OSSF Inspection Sheet

Permit of Authorization to Construct an On-Site Sewage Facility Permit Valid For One Year From Date Issued

Permit Number: 117197
Issued This Date: 03/28/2024
This permit is hereby given to: CHRISTOPHER & SERIKA RILEY

RE- SEPTIC DESIGN
2214 MERITAGE
VINTAGE OAKS AT THE VINEYARD, UNIT 8, LOT 1089
NEW BRAUNFELS, TX 78132
RILEY RESIDENCE

| PREPARED BY: GREG W. JOHNSON, P.E. F#002585 | SCALE: 1"=40' | DATE: 2/7/2024 | REV3: 5/3/2024 |

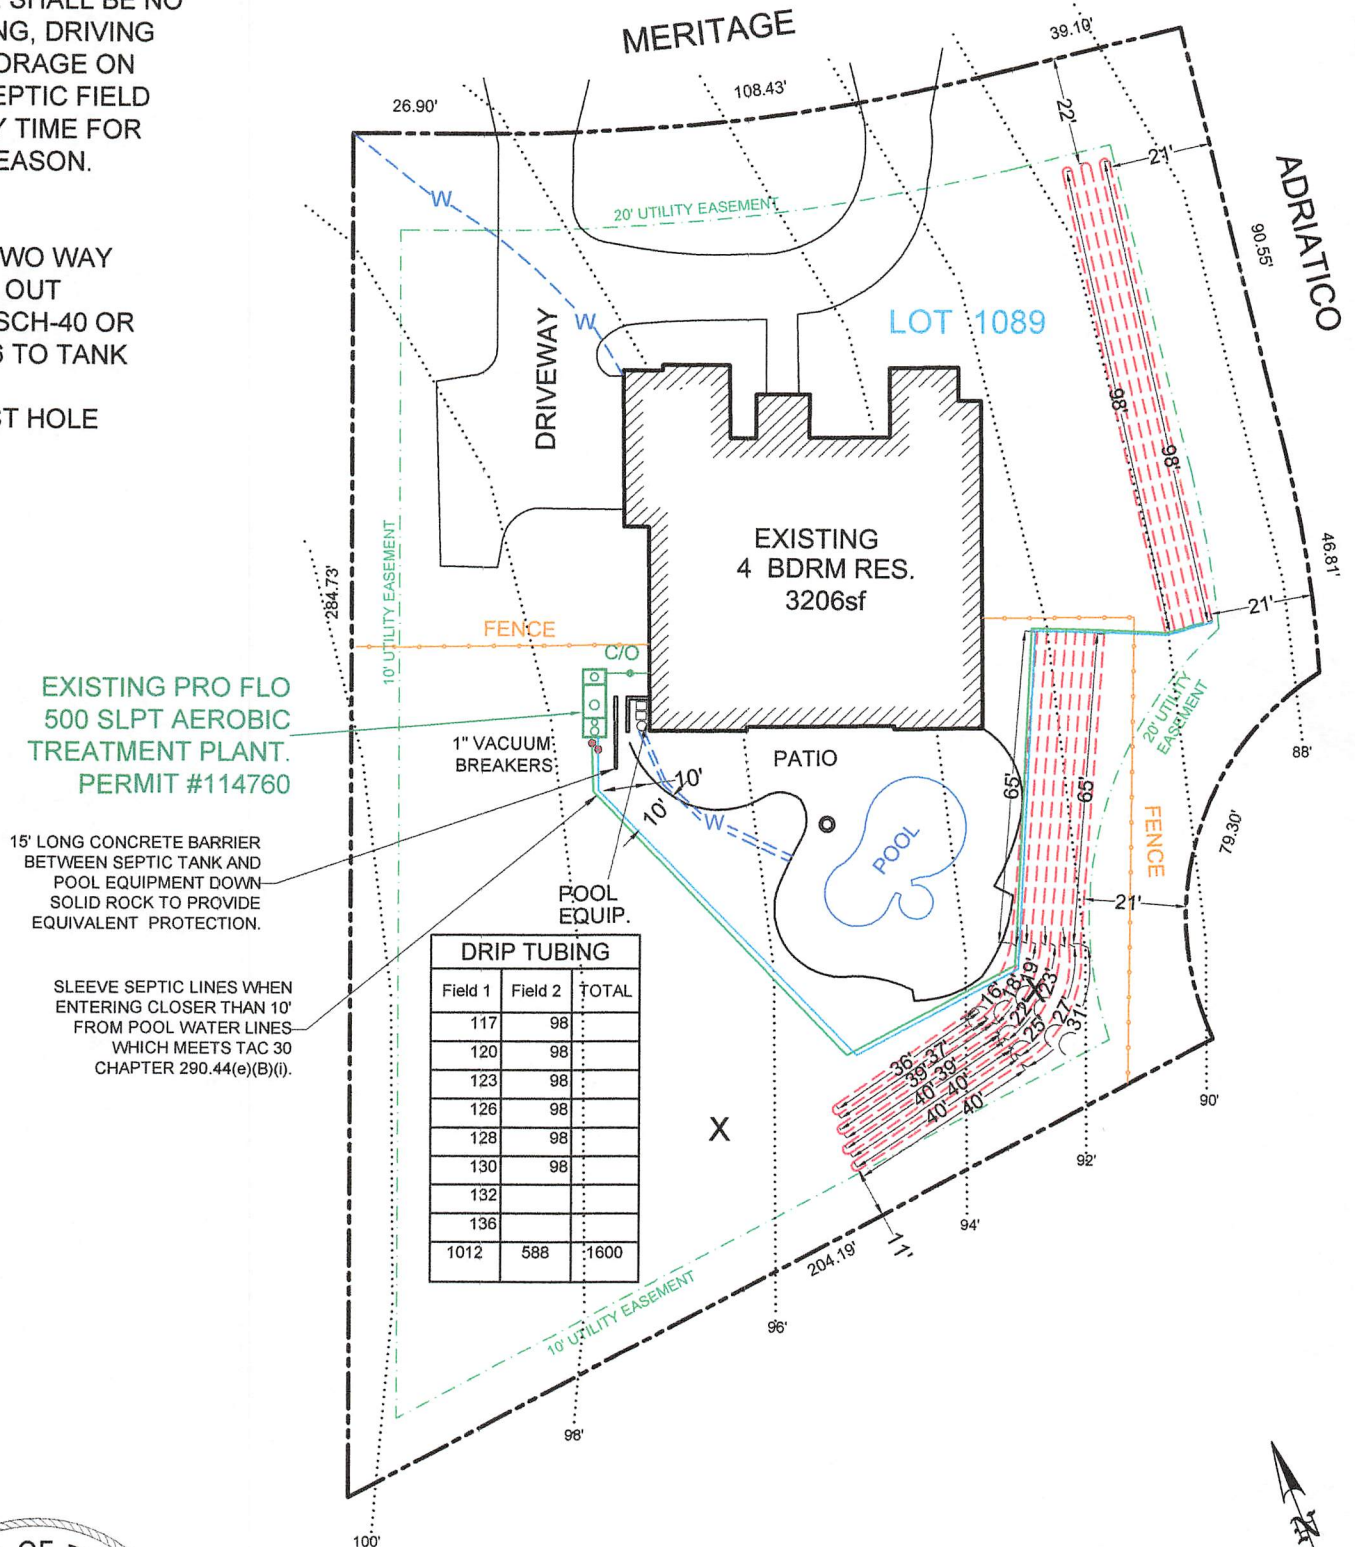
A preliminary inspection conducted on 3/1/2024 found that there is a concrete wall within 5 ft of the tank and pool lines within 10 ft. of the tank. Revise as needed and resubmit.

A preliminary inspection conducted on 3/1/2024 found that there is a concrete wall within 5 ft of the tank and pool lines within 10 ft. of the tank. Revise as needed and resubmit.

Revised to show concrete filled trench to solid rock between existing pool equipment/pool lines & existing aerobic tank to provide equivalent protection.

I hereby respectfully request a variance to five foot setback from tank to the concrete pool equipment pad and ten foot setback between pool lines and aerobic tank.

15' LONG CONCRETE BARRIER
BETWEEN SEPTIC TANK AND
POOL EQUIPMENT DOWN
SOLID ROCK TO PROVIDE
EQUIVALENT PROTECTION.

| PREPARED BY: GREG W. JOHNSON, P.E. F#002585 | | | SCALE: 1"=40' | | DATE: 3/28/2022 | | REVISED: |

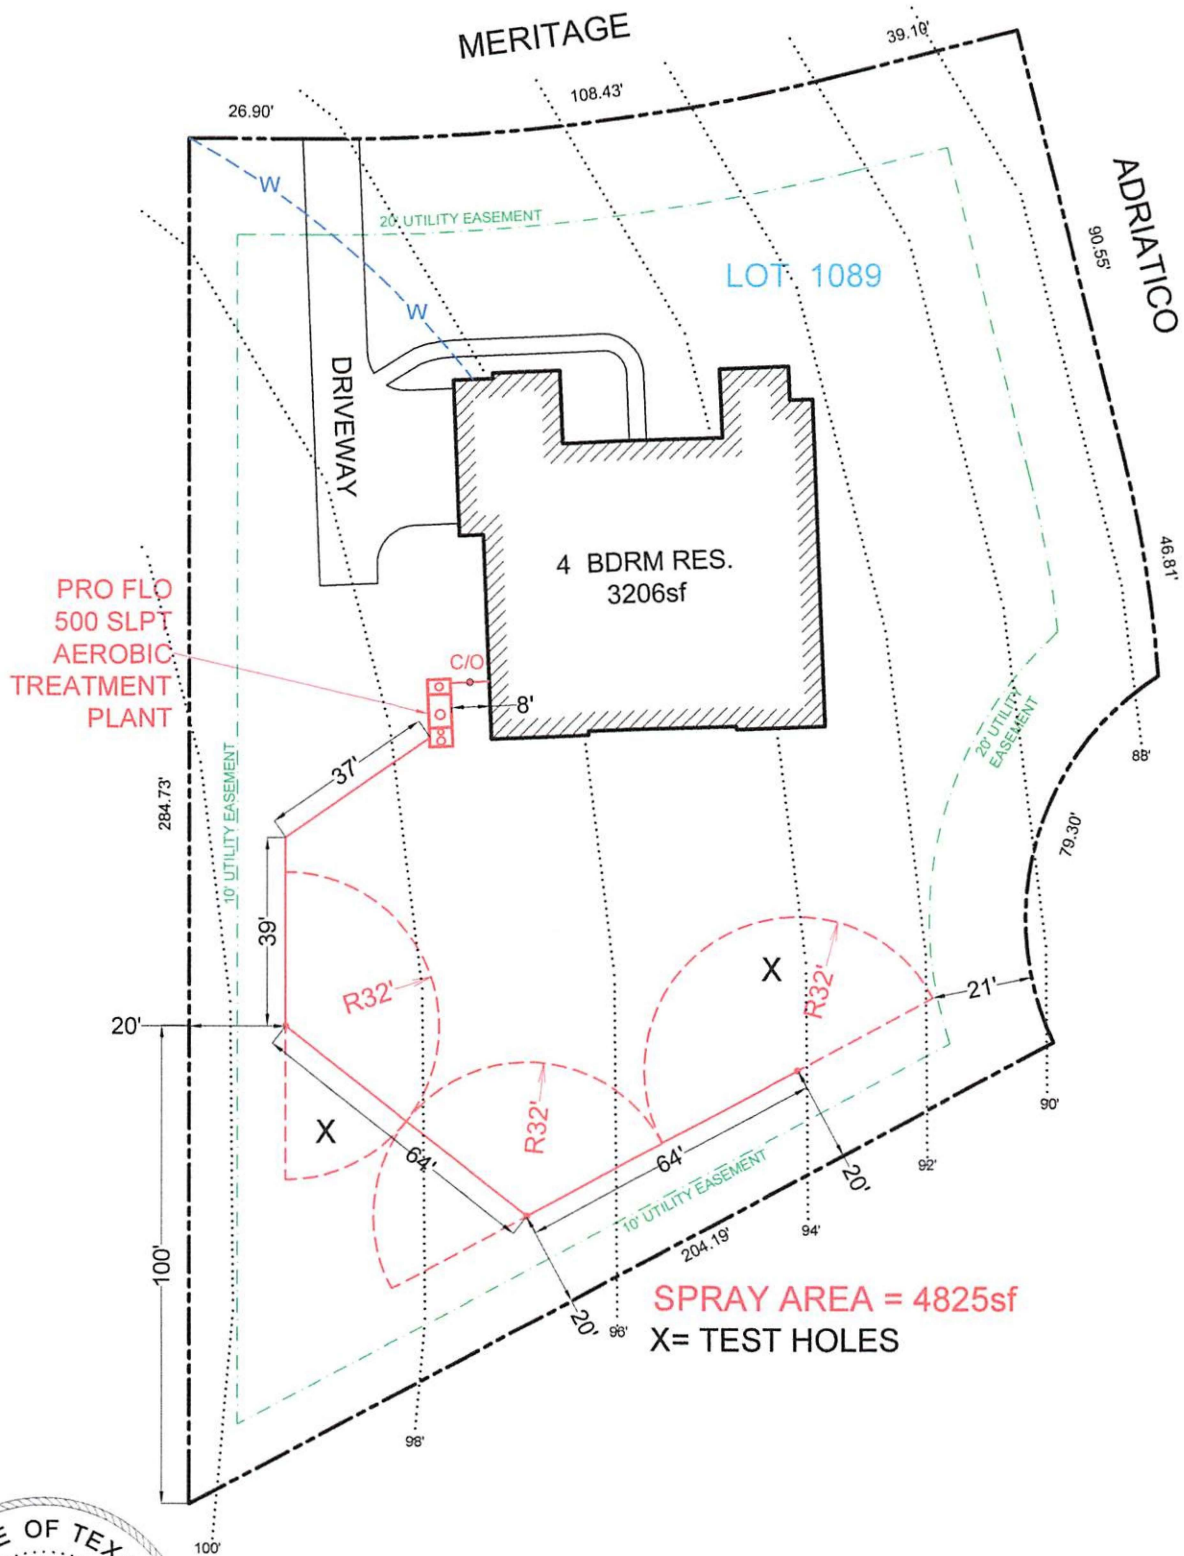
- ✓ **All property owners as identified on the warranty deed must sign the permit application.**
- 2. Verify that all pool lines will be at least 10 ft. from all OSSF components.**
- 3. A preliminary inspection has been scheduled for today. Additional comments may be necessary once complete.**
- 4. Revise as needed and resubmit.**
